Cimarron Environmental Response Trust	
	License Condition 27(e) Change Evaluation Form	
	<i>Cimarron Radiation Protection Plan, Rev. 4</i>	Page 1 of 6

Revision 3.2 of the Cimarron Site Radiation Protection Plan (RPP) is being revised as shown in the attachment to this evaluation. The changes that will be incorporated into Revision 4 of the RPP include the following:

Cimarron Environmental Response Trust	
	Radiation Protection Plan	
Document No. RPP-001	Rev. 3.24	Effective date: 9/15/2019 3/1/2021
		Page i

Figure 3-1

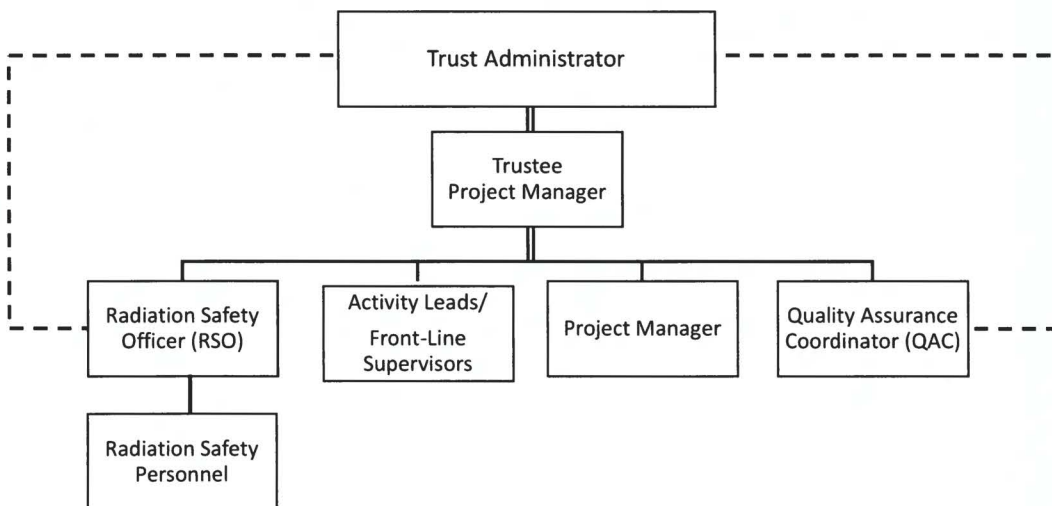
Commented [JM60]: Rev. 3.2 to Rev. 4: Editorial change to add "Front-Line Supervisor" to Activity Leader block for consistency with Section 3.2. This change was not included in the Draft Rev. 4 reviewed by the NRC staff.

Figure 8-1

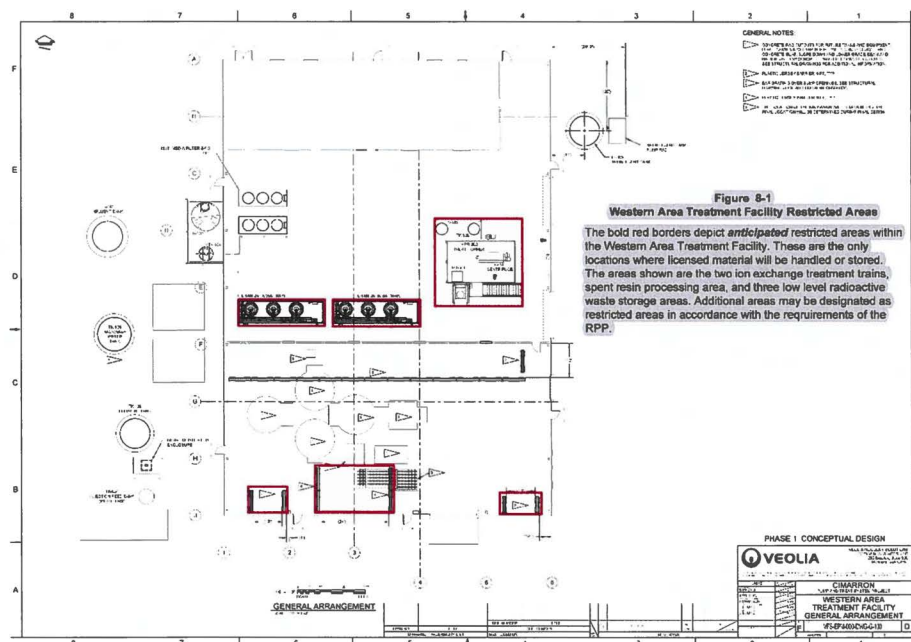
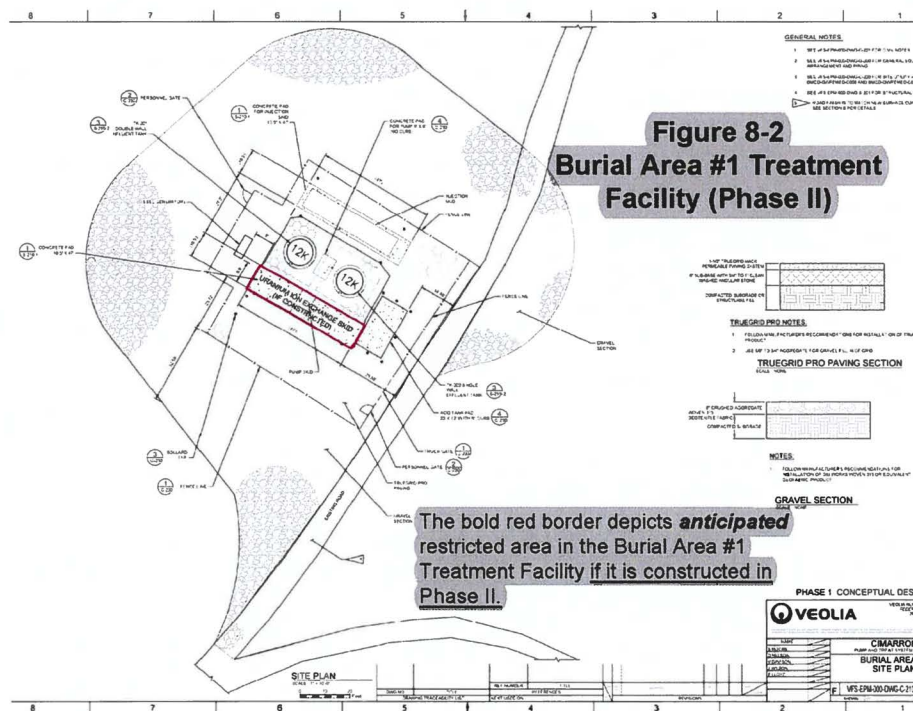
Commented [JM122]: Rev. 3.2 to Rev. 4: Figures 8-1 and 8-2 have been updated from those that were provided in response to supplemental information requested by the NRC staff during their review of Draft Rev. 4. These figures do not apply to current Site activities and are shown in GRAY HIGHLIGHT.

Figure 15-1

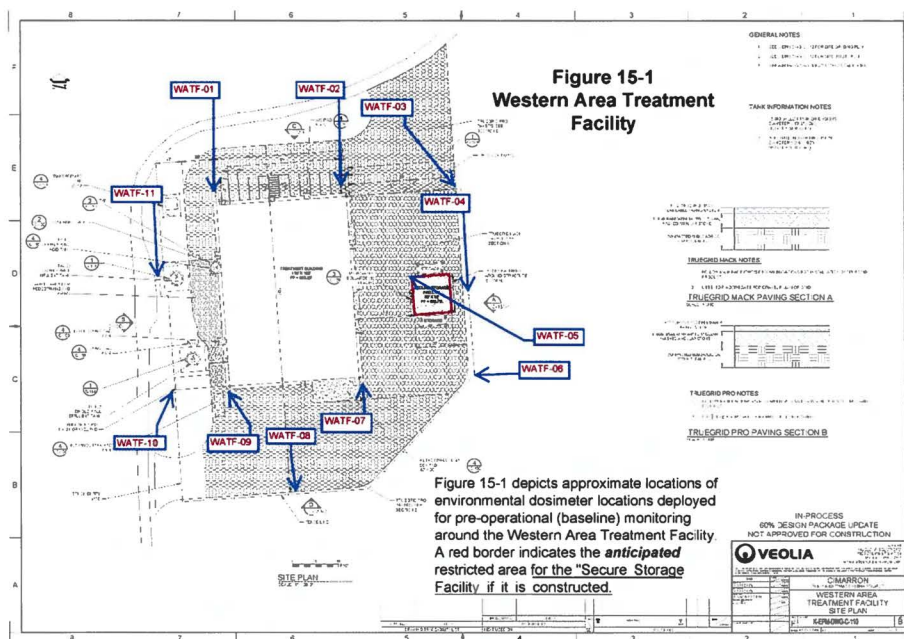
Commented [JM183]: Rev. 3.2 to Rev. 4: This figure was included for consistency with the DP. These changes recognize the baseline environmental dose monitoring program being conducted at the Site. These changes were not included in the Draft Rev. 4 reviewed by the NRC staff.
